SR 25 CO/West Bay Street From I-516 to the Bay Street Viaduct

NHS00-0002-00(923), P.I. No. 0002923
Chatham County, Georgia

Value Engineering Study Report

September 2009

ALT. NO. G-1
Sht 5 of 15

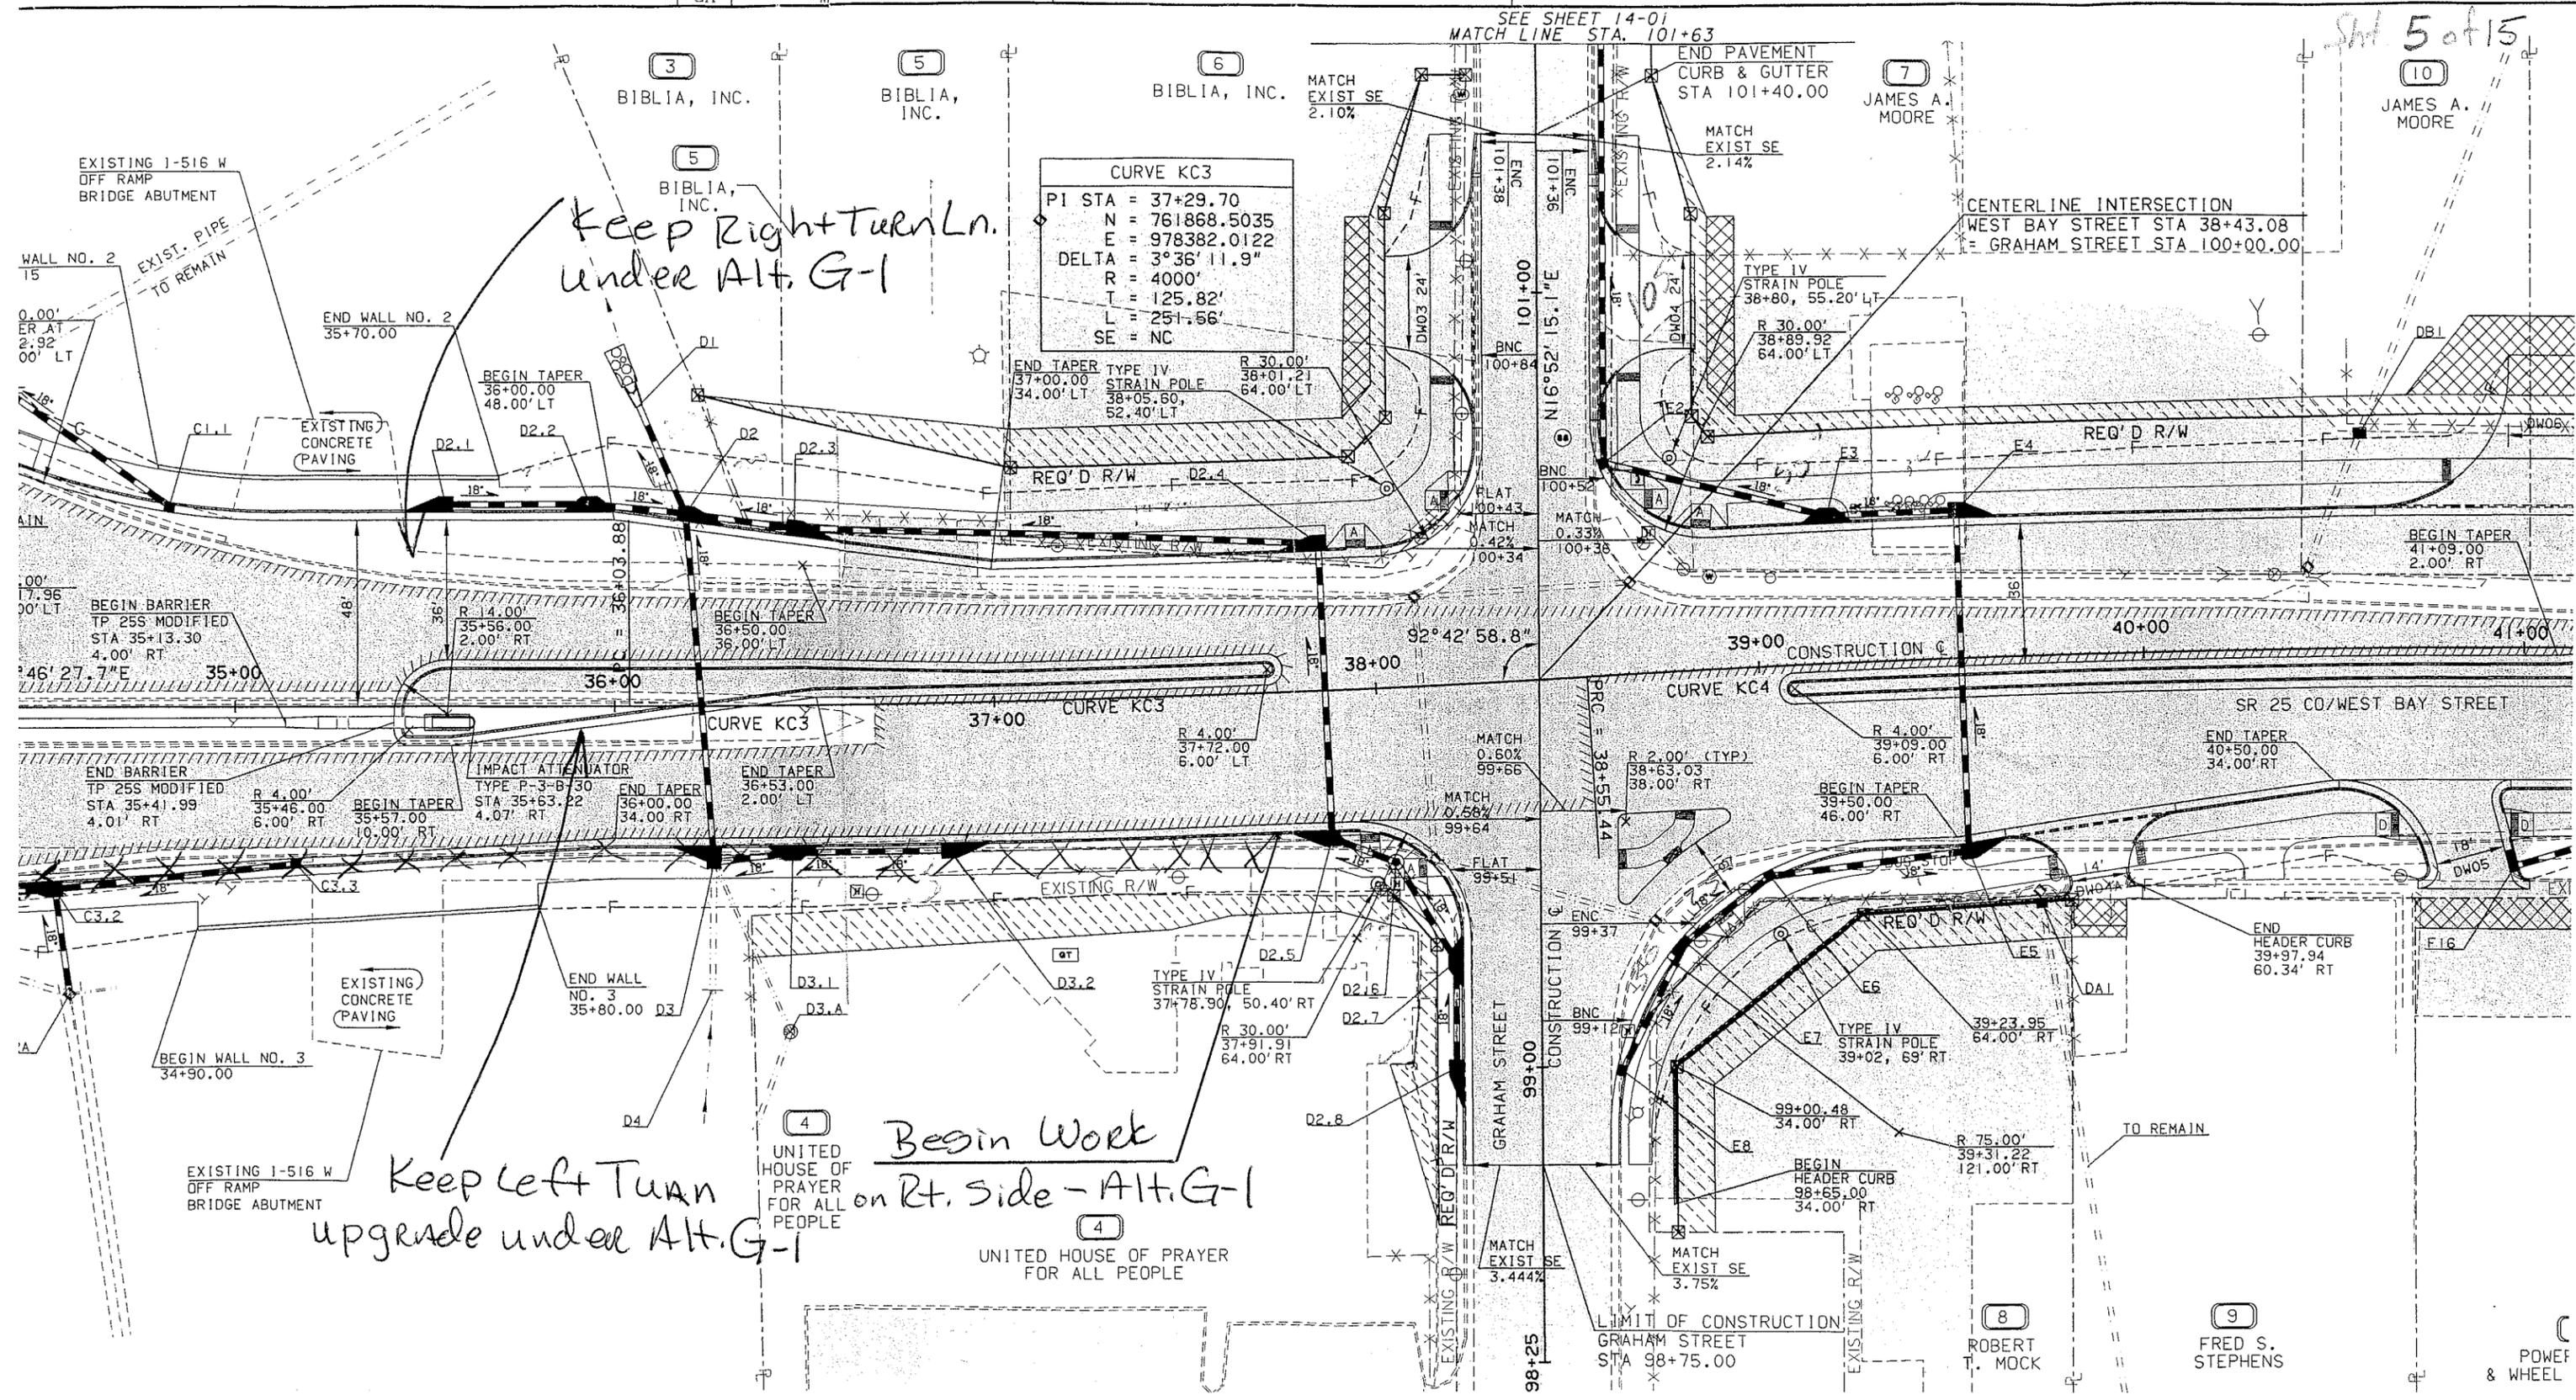
The necessity for the U-turns at this location is questionable. The limited number of vehicles desiring to go west on SR 25 CO/West Bay Street from Old West Lathrop Avenue could go to Augusta Avenue, turn left onto Augusta Avenue, left onto northbound West Lathrop Avenue and left onto SR 25 CO/West Bay Street.

It is also questionable whether the sidewalk on the north side of SR 25 CO/West Bay Street is needed. In order to use this sidewalk, a person would have to cross the free flowing entry ramp to I-516 westbound, which is not safe. In addition, the origin and destination of potential users of this sidewalk is not readily apparent.

Providing a protected right turn from eastbound SR 25 CO/West Bay Street to southbound West Lathrop Avenue is questionable given the maximum hourly volume of 23 vehicles.

Work eliminated under Alt. G-1

2 of 4

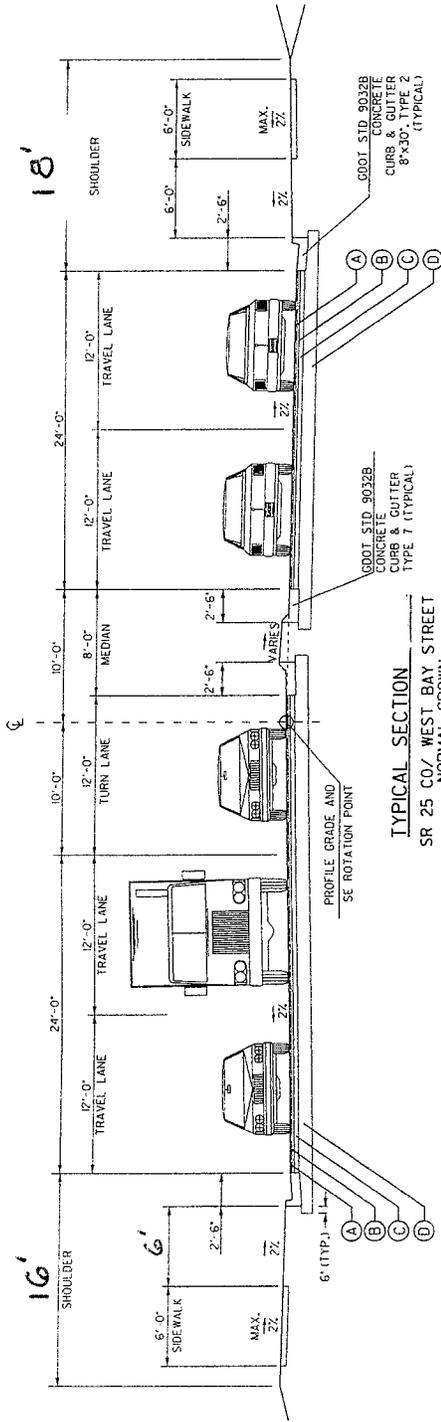
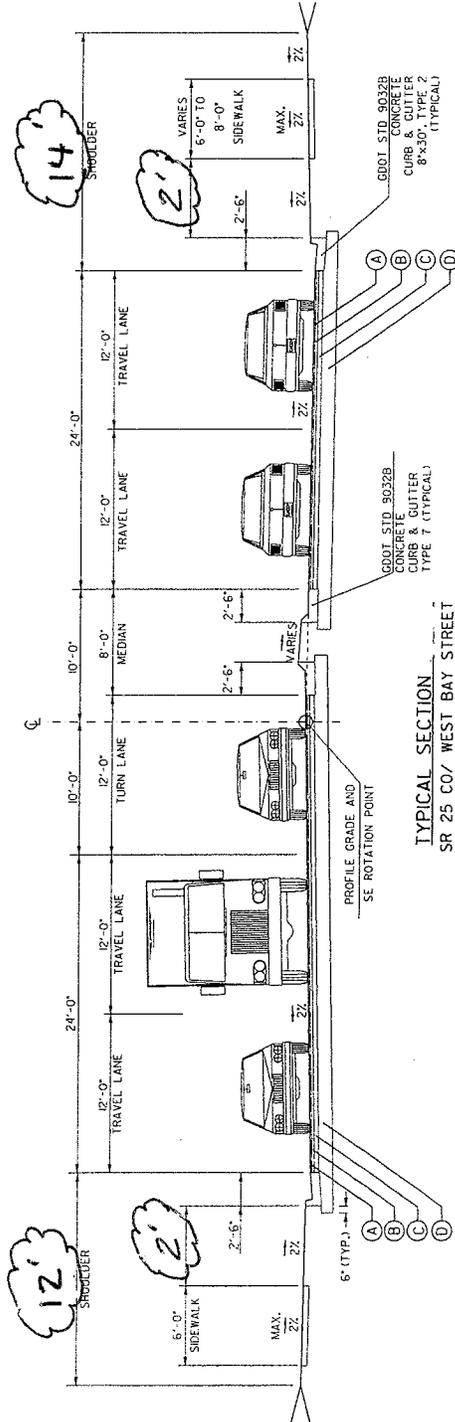
Original Shoulders
